Re: Renovation/Alterations  
4 Ledgewood Place  
Armonk, NY 10504  
Tax ID: 107.02-2-46

**RPRC DETERMINATION LETTER 7/3/2019 RESPONSE**  
**RPRC DETERMINATION LETTER 11/6/2019 RESPONSE**  
**STAFF REPORT-TOWN OF NORTH CASTLE 3/20/2020 RESPONSE**

Following is a point by point response to comments on the project made via the above listed memos. The comments from the RPRC Determination Letter, dated July 3, 2019 and Nov. 6, 2019 have been copied into this letter. Responses follow each RPRC comment in blue for clarity:

CULTEC 330XLHD STORM WATER SYSTEM  
TYPICAL CROSS SECTION DETAIL  
SCALE: 3/8" = 1'-0"

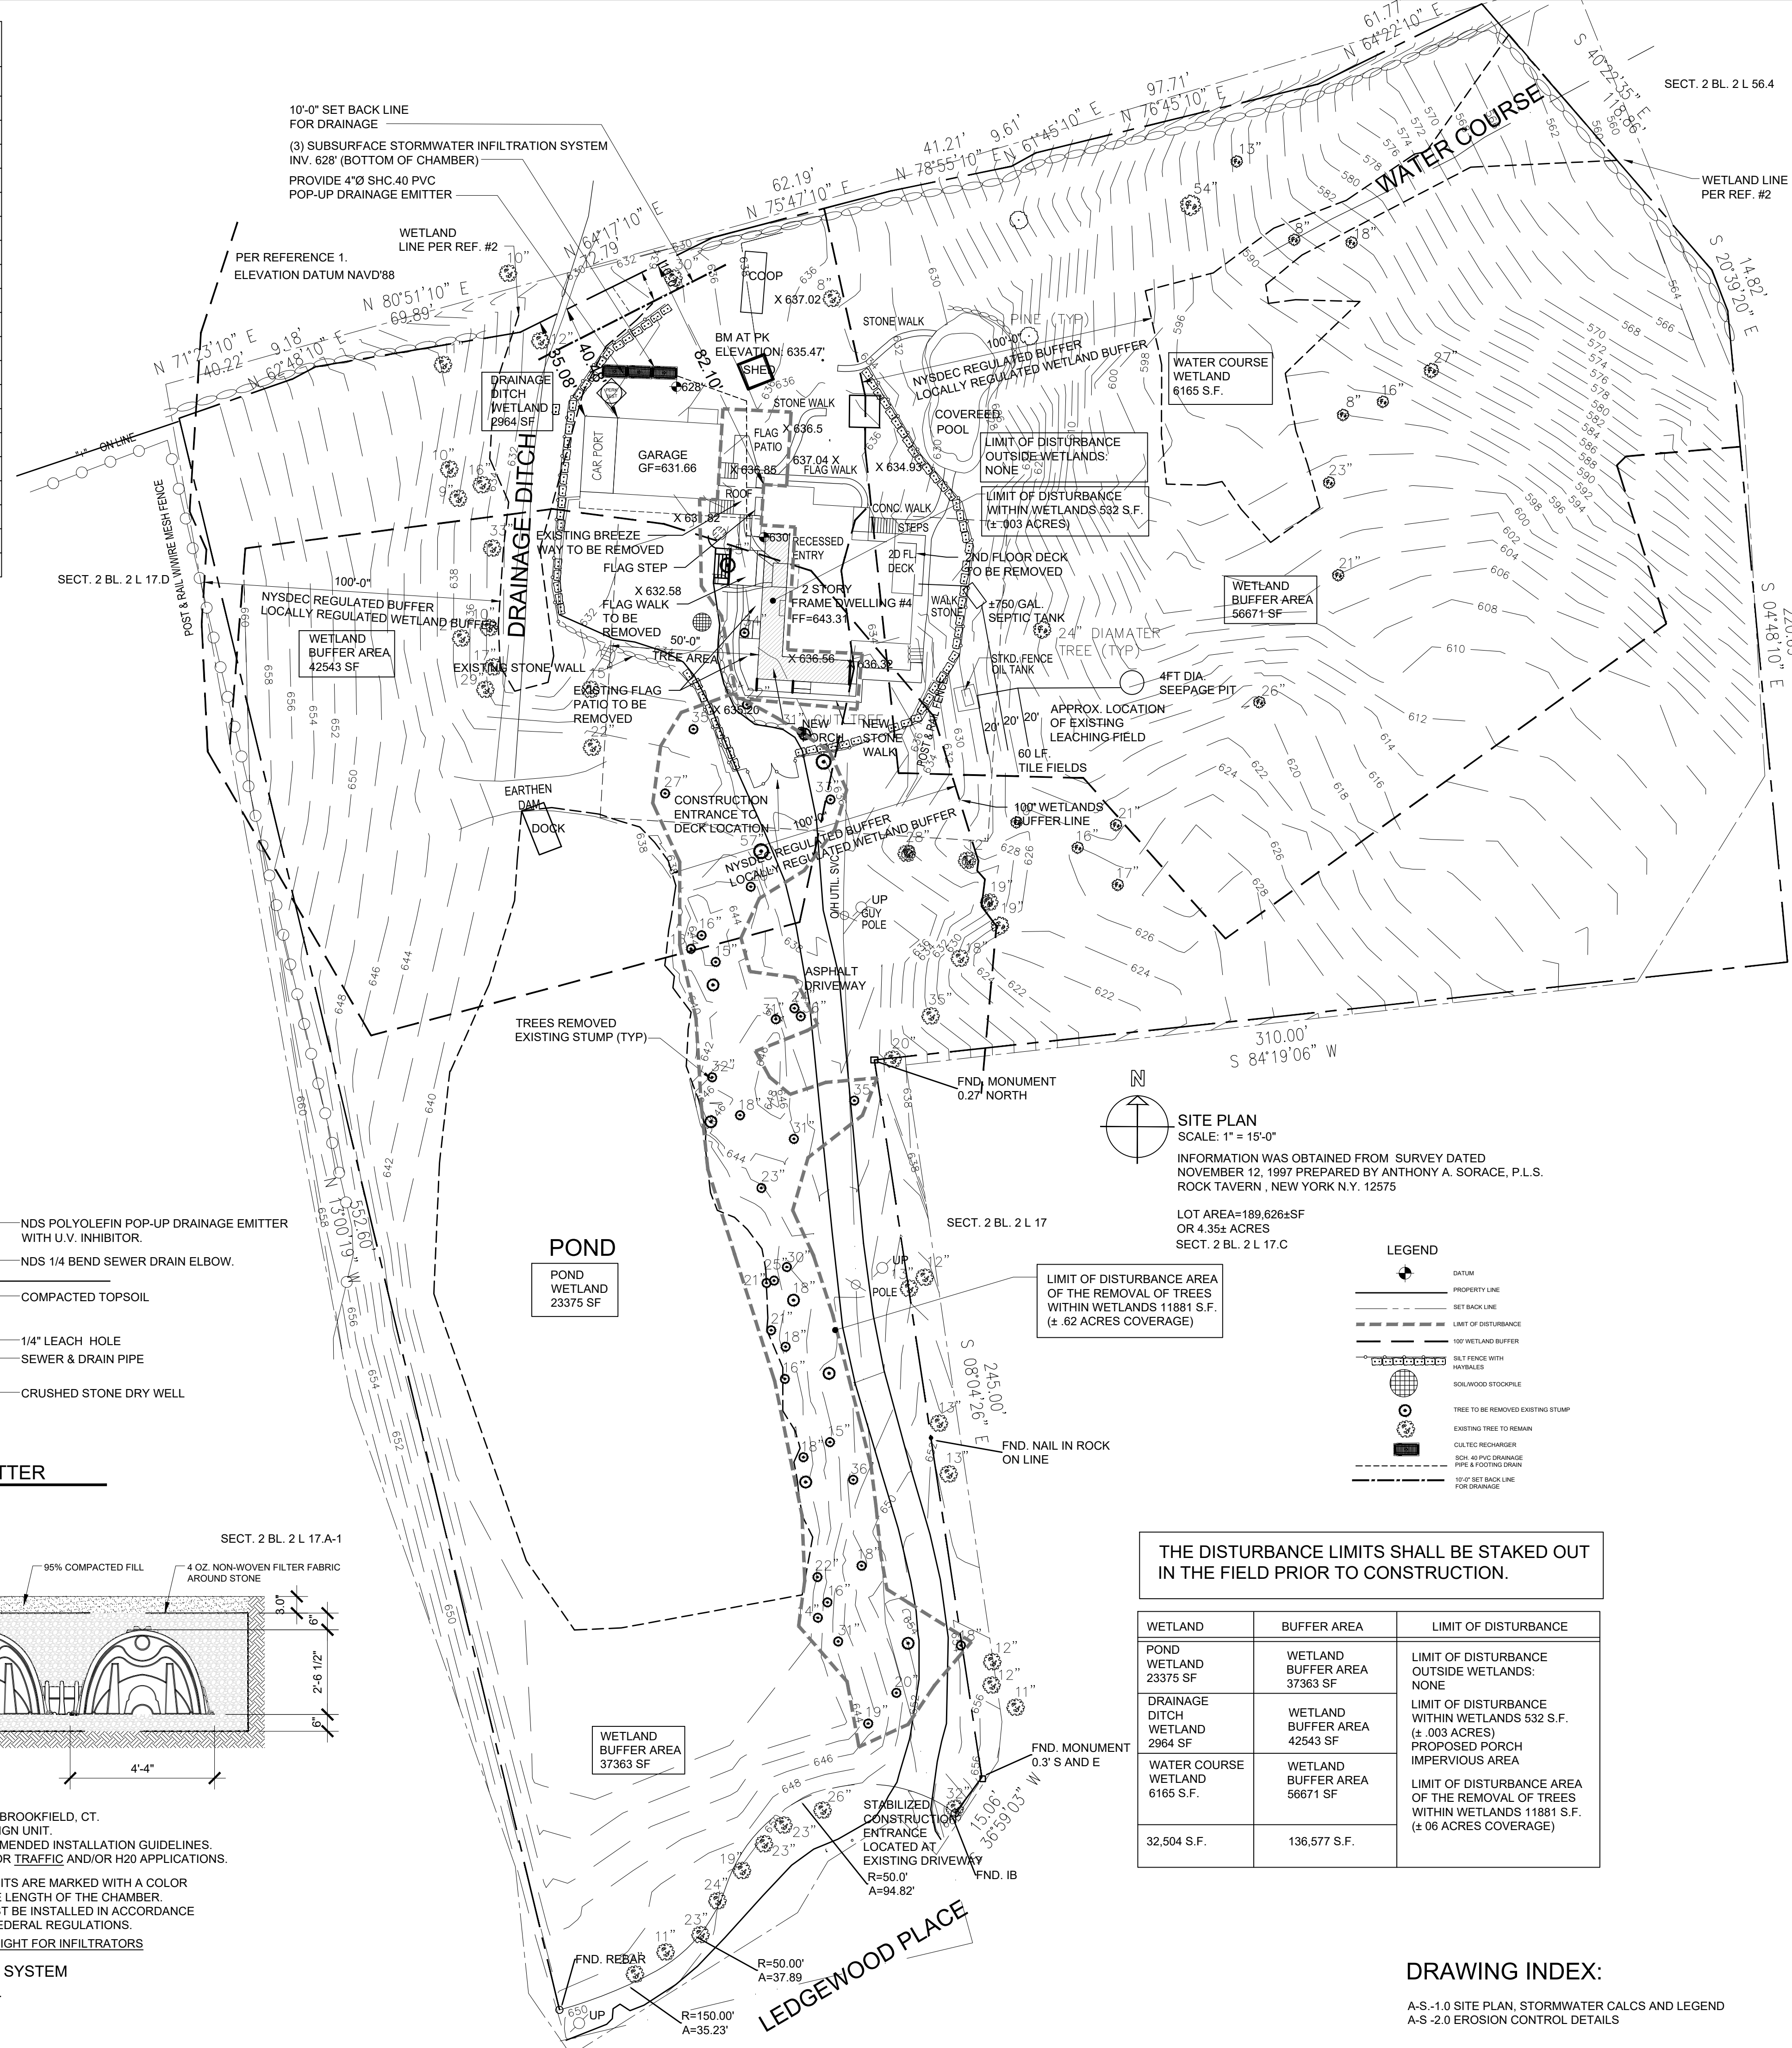
19. Provide stormwater mitigation and design calculations for the runoff generated by the net increase in impervious surface for the 25-year, 24-hour design storm event. Provide details of the stormwater mitigation system. Storm water mitigation and design calculations and details have been added to the drawing set.

LOT & BUILDING  
COVERAGE DIAGRAMS

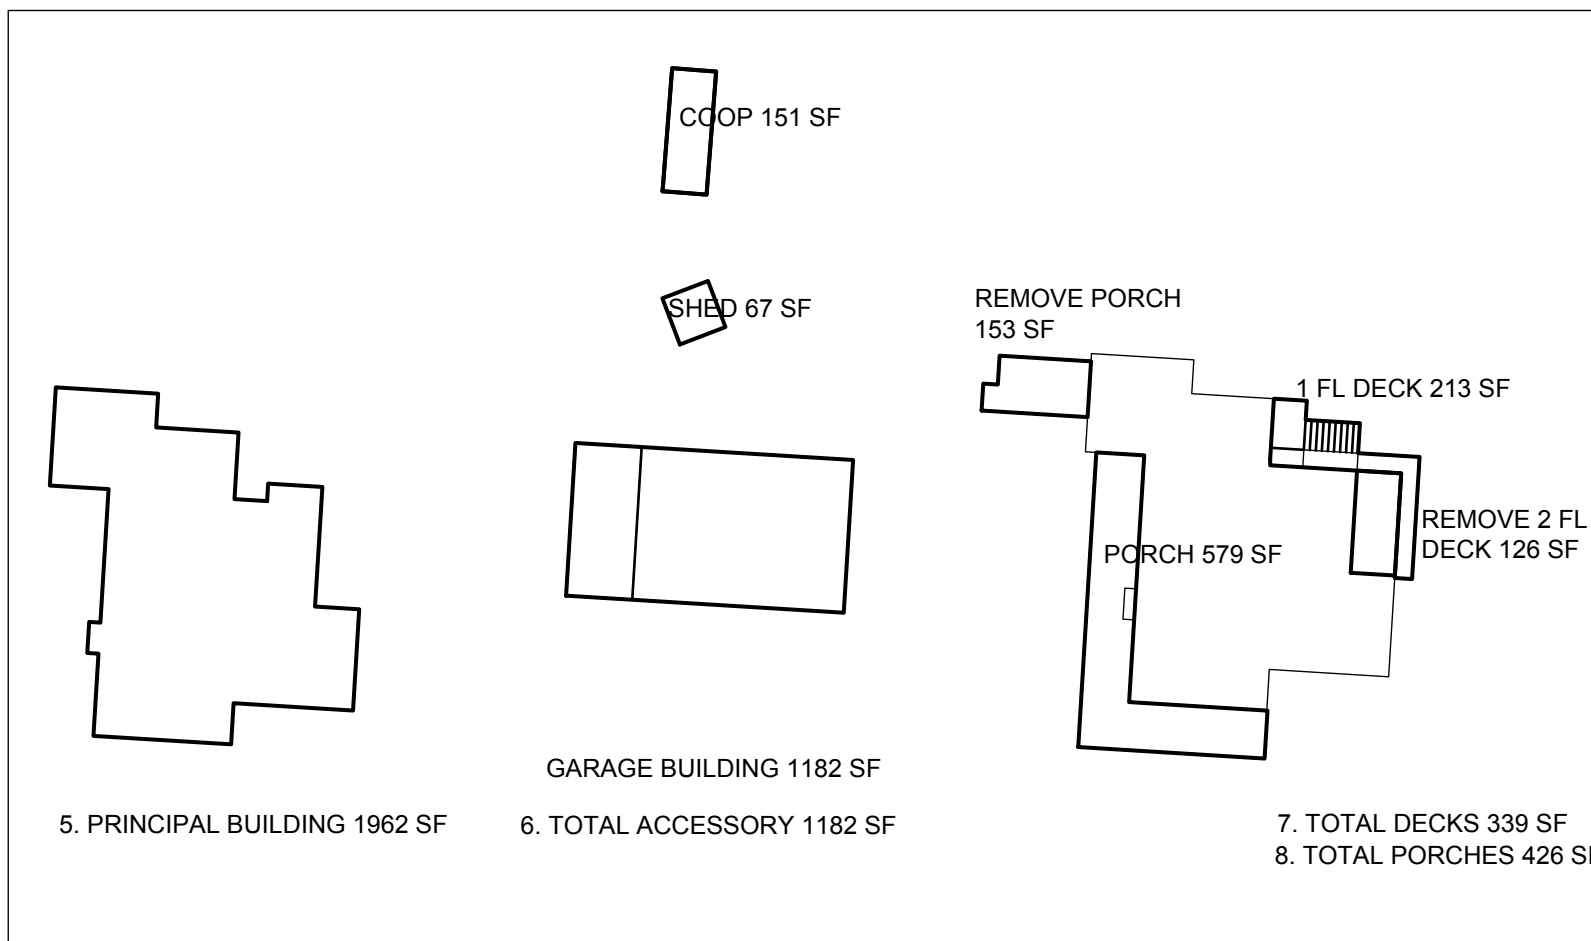
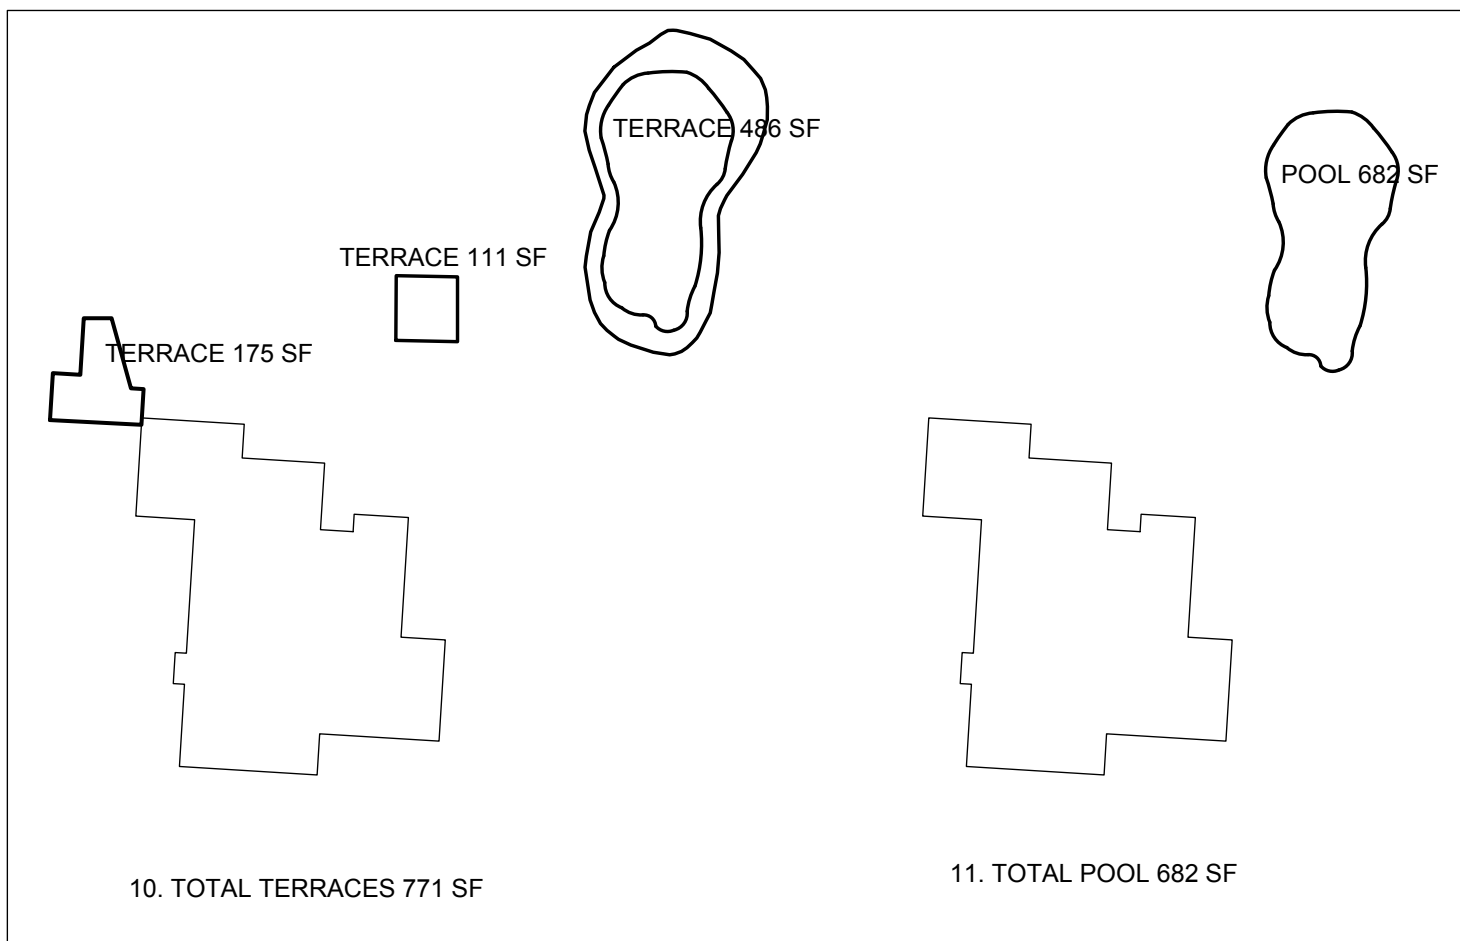
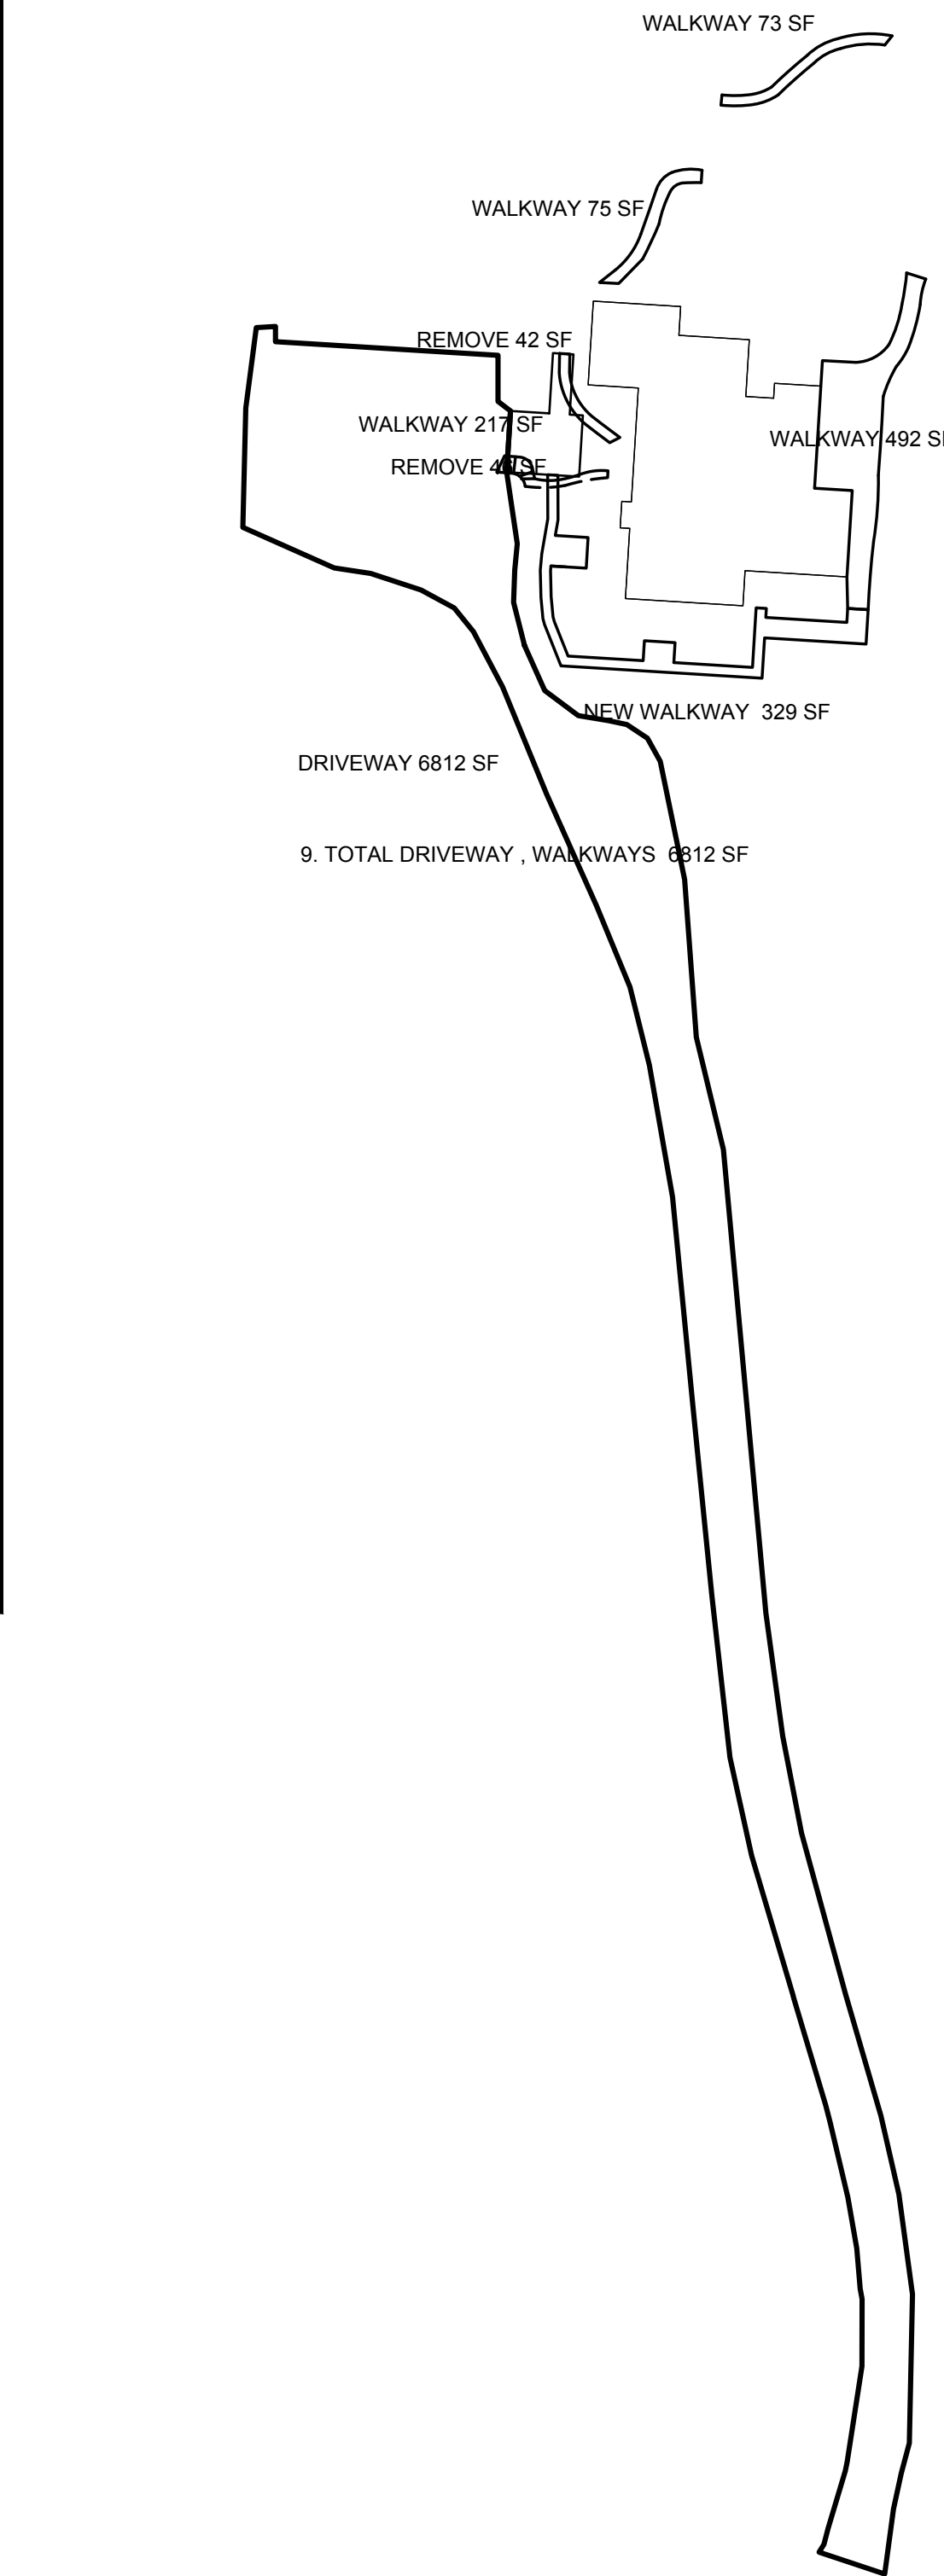
[Item #5- Gross Land Cover Worksheet and Backup information is attached. See Drawing Z-100](#)

[Item #6- Gross Floor Area Calculation Worksheet and Back up Data is attached. See Drawing Z-100](#)
